## ASSESSMENT REPORT

### Block 11 - Central Park, Chippendale (Former Carlton United and Brewery Site) SSD 6376 MOD 1

**Figure 3: Wind measurement locations at O'Connor Street Park and the retail units (Base image source: Modification application)**

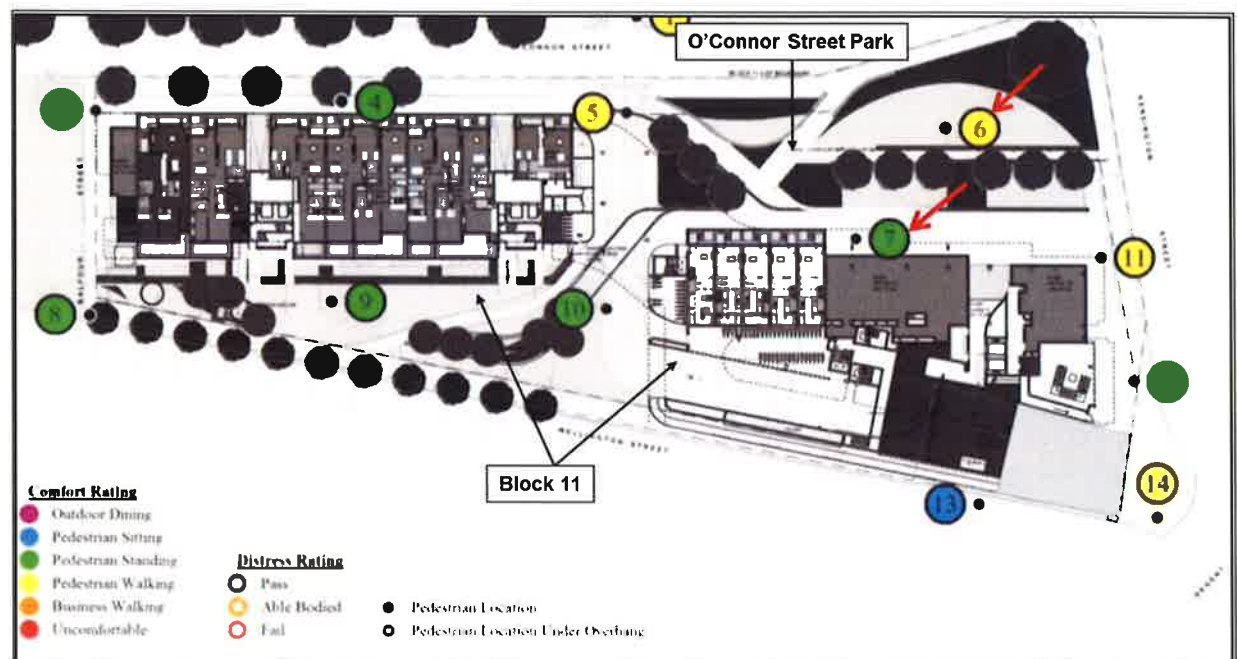
The applicant asserts that:

- it is not able to meet the wind requirements of condition B7 ('pedestrian sitting' comfort level) given the site constraints;
- the planting of a significant number of trees within the park would have a negligible impact on wind reduction and would form a visual barrier;
- planting would reduce solar access and security within the park; and
- wind impacts within the park are similar to other nearby inner city parks.

As proposed, the planting within O'Connor Street Park, achieves a wind environment providing a 'pedestrian walking' comfort level, similar to a number of other inner city parks, such as Tumbalong Park. The Department notes the Wind Report states that to meet a 'pedestrian sitting' comfort level within the park as required by the condition, mature trees would need to essentially cover the full extent of O'Connor Street Park. This would result in other adverse amenity impacts, such as loss of solar access, which would also reduce the utility of the park for passive recreation.

The Department considers additional wind amelioration measures would not be practicable in this instance for the following reasons:

- the significant tree planting required to reduce wind impacts would reduce usable open space, solar access and safety and security within the park. Therefore, compliance with the condition would potentially result in a net loss of amenity;
- despite not having a suitable wind environment for pedestrian sitting, the park would still provide a pleasant place to sit on non-windy days, a suitable space for passive recreation, a pleasant pedestrian connection and landscaping which complements other nearby open space including the adjacent Chippendale Green;
- the wind environment is similar to many other open spaces within inner city locations where the urban form comprises high density development; and
- residents have access to other nearby open space, such as Chippendale Green, which achieve comfort ratings suitable for 'pedestrian sitting'.

The Department also notes that the original concept plan for Block 11 did not include a consolidated park at this location. While the proposal does not achieve the desired wind environment, the park would still provide additional green space within this inner city location for the benefit of the community. On this basis, the Department is satisfied the proposal is acceptable.

Figure 4: Location of vertical screens to retail units (Source: Modification application)

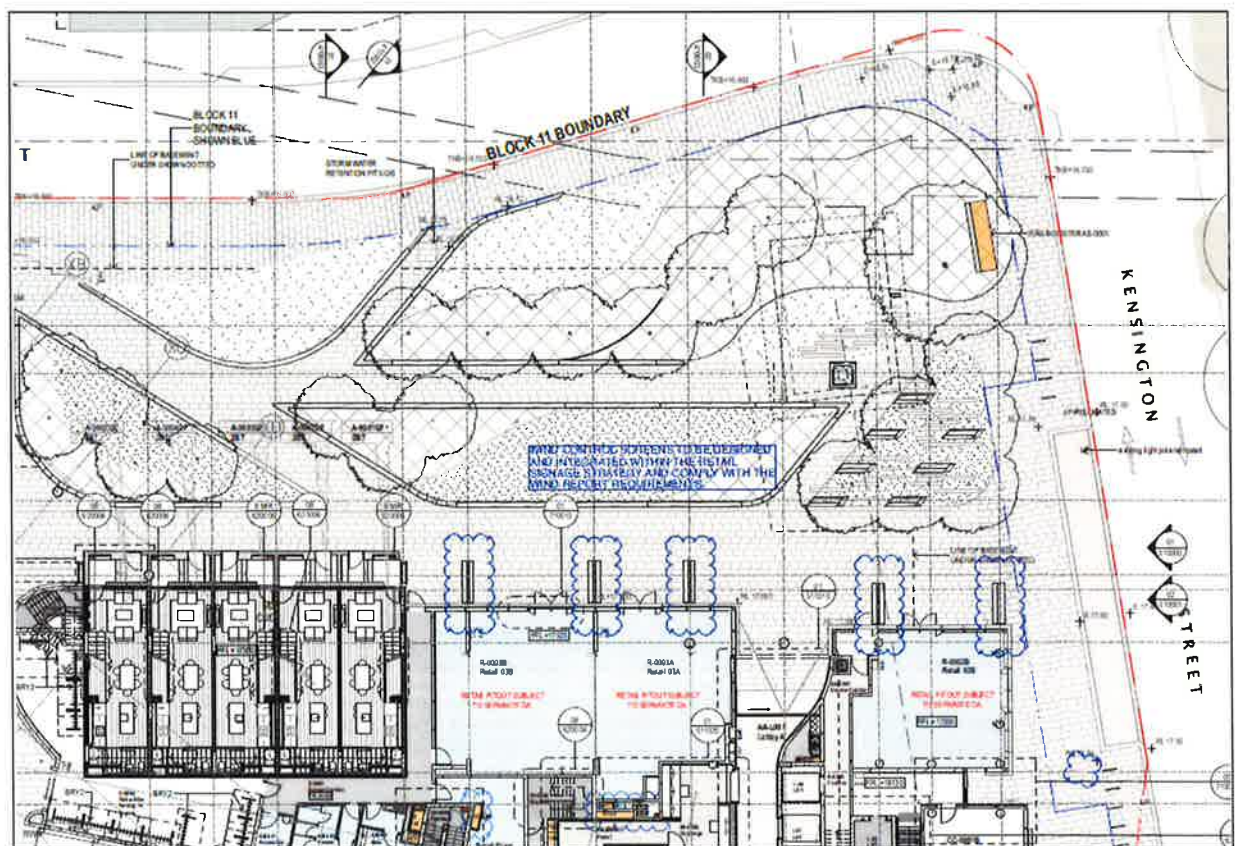
To address wind impacts outside the retail units the modification includes the installation of vertical screens, with climbing plants, angled perpendicular to the ground floor retail unit frontages (refer to **Figure 4 and 5**). The Applicant has stated that subject to the installation of the screens, the areas between them would meet the 'pedestrians sitting' criterion without the need for additional shielding.

The applicant has also confirmed the outdoor childcare space would achieve a 'pedestrian sitting' comfort level following changes to the geometry of the building and the inclusion of landscaping and perimeter balustrading.

To ensure the proposed vertical screens to the retail units do not have an adverse security impact, the Department considers appropriate sightlines should be retained through the screens. The applicant has confirmed while planting is required to mitigate wind impacts, views could be retained through the screens subject to appropriate species selection. The Department has therefore recommended the inclusion of a condition requiring appropriate views be maintained through the screen.

The Department considers the treatments proposed for the retail units and childcare facility adequately ameliorate wind impacts to these spaces and address the aims of Conditions B8 and B9.
